# Office Action Summary

09/521,367

KARASAWA, HITOSHI

## **DETAILED ACTION**

Figure 1

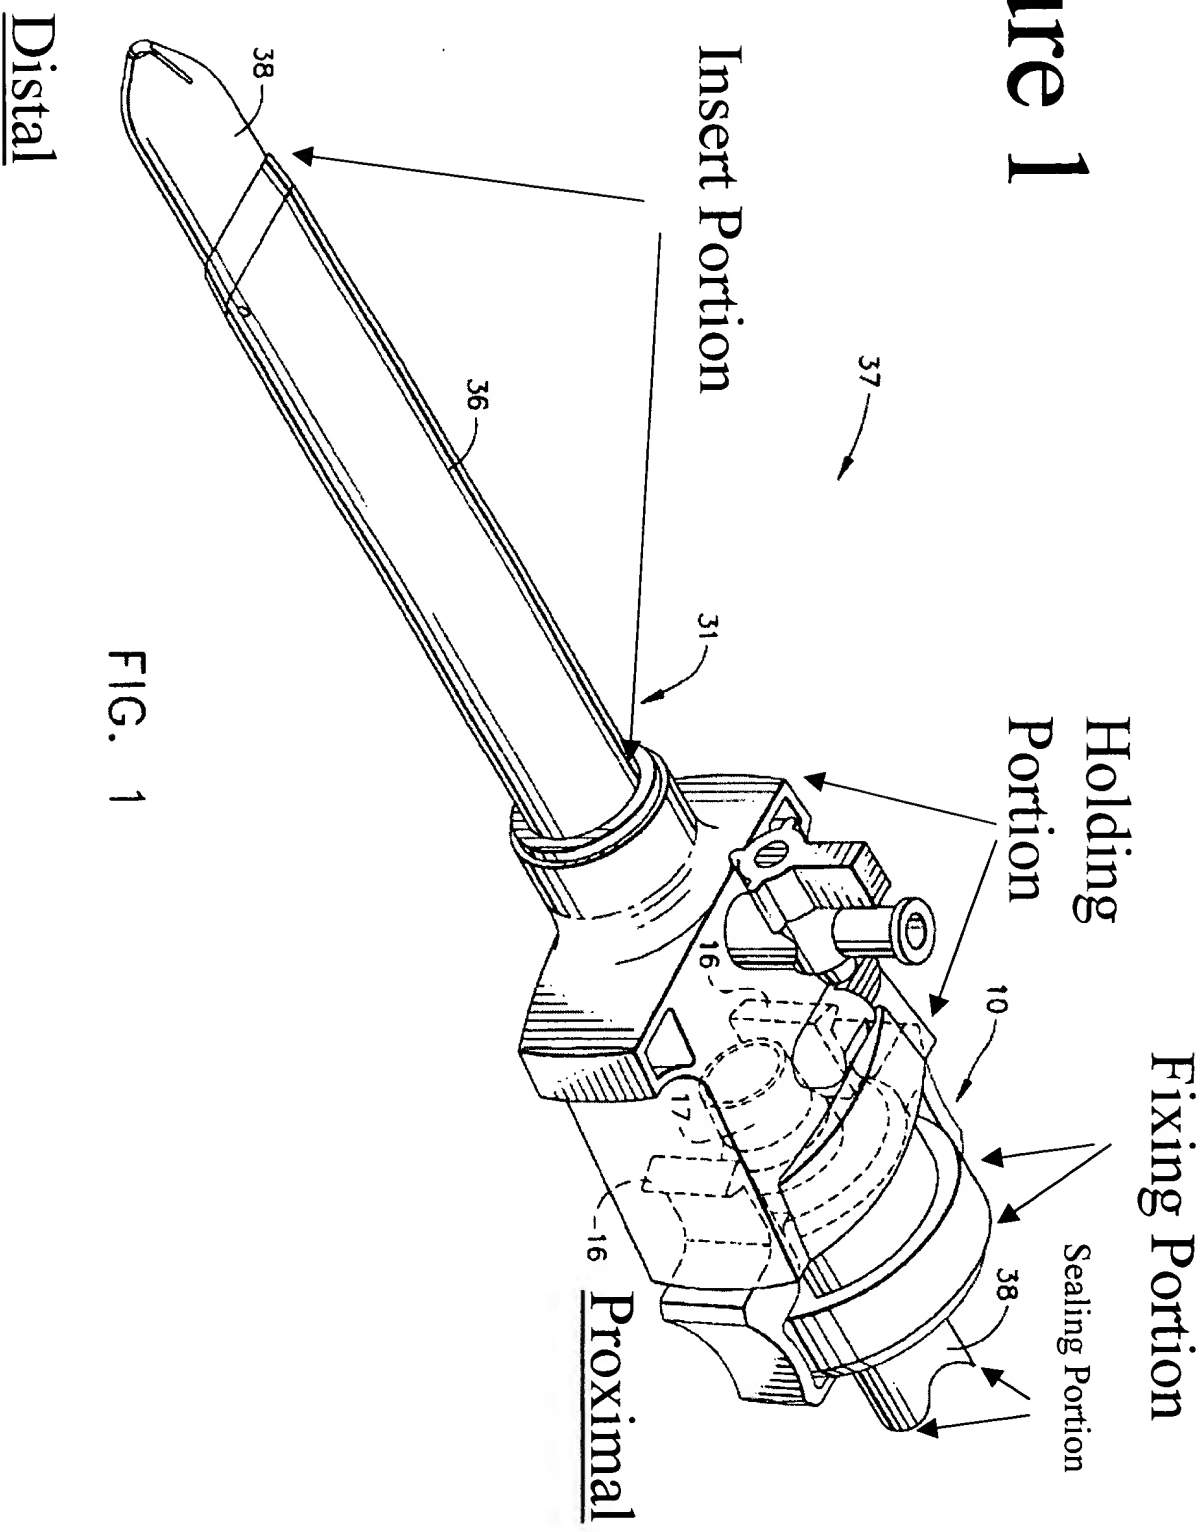
8. Claim 1-5,8,10,15,16,18, 19, 20, & 23 are rejected under 35 U.S.C. 102(b) as being anticipated by Kramer et al 5,792,113. Kramer teaches that a trocar can be assembled with:

- An insert portion capable of allowing a medical instrument to pass through it
- A holding portion equipped with an opening
- A removably mounted sealing member mounted to the holding portion
- A fixing member removably mounted to the sealing member

Please see the attached page figure 1. All of these parts are clearly labeled. The figure was taken from figure 1 in Kramer's patent 5,792,113.

- A housing with a space (column 2 line, 43-44)
- A port/passage for a surgical instrument (column 2, lines 64-65)
- A sealing means for closing the port (column 1, lines 30-33)
- A fixing member for fixing the sealing means. (see attached figure 1)
- A removably mountable sealing means (see attached figure 2, items 10, 16, 17)
